Recommended Items for 2016

The following is a summary of proposed rule changes made by the Club Racing Board. These items will be presented to the Board of Directors for approval. Comments, both for and against, should be sent to the Club Racing Board via <http://www.crbacca.com> or www.clubracingboard.com. If approved, these rule changes will become effective 1/1/2016, unless indicated otherwise. The letter number, Fastrack month, author, and title precedes each proposed rule.

Recommended Rules Changes (October 2015)

2. #16783 (May Fastrack – Club Racing Board) Update to 9.1.7.C.1.a.1.f.5
Replace the entirety of 9.1.7.C.1.a.f.5

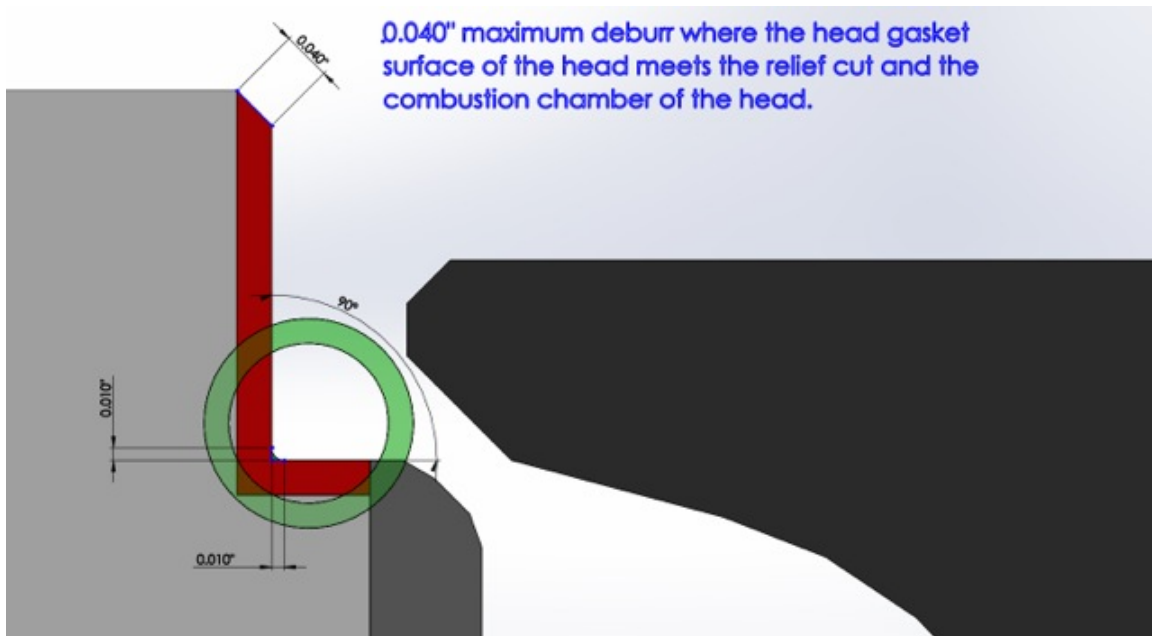
UPDATE: 5/20/2015, Due to member input, the Club Racing Board recommends changes to this letter. “.040” changed to “.010” on the bottom of the relief cut. Drawing published on scca.com 4/24/15 has been removed. New drawing is attached..

New: 5. Unshrouding of valves is explicitly limited as follows: The wall of allowed relief cut must be a single cut parallel and concentric with the valve guide for the full depth of the cut. The cut must be cylindrical with no taper. The bottom of the cut must form a 90 degree angle with an allowance for a bevel or curve whose radius is not to exceed .010”. There must be a sharp, non-modified and non de-burred edge where the valve relief cut first meets the chamber. No part of this cut (except where it intersects the head gasket surface, which may be de-burred up to .040”) is to be blended by hand, machined, or chemically processed to create a smooth transition. See diagram below. The maximum dimensions, measuring guide center line to chamber edge:
